Customer Bulletin

Groomer Drive Direction Knob Falls Off Universal Groomer Drive (Greens)

Model Number(s)	Serial Number(s)
04648	318000001 to 319999999
04707	318000001 to 319999999

- 1. O-ring
- 2. Knob

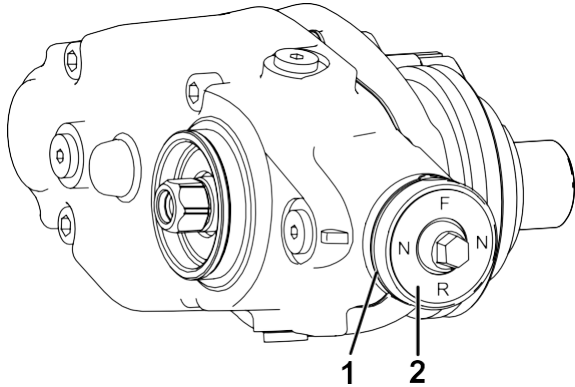
The sun's ultraviolet rays can cause the O-ring on the groomer-direction drive knob to deteriorate, which allows the set pin and knob to fall off of the groomer-drive housing.

If the O-ring deteriorates, install the Groomer Knob Kit (Part No. 137-0959), which includes a new groomer-drive knob and hex-socket bolt. Refer to your authorized Toro distributor for more information.
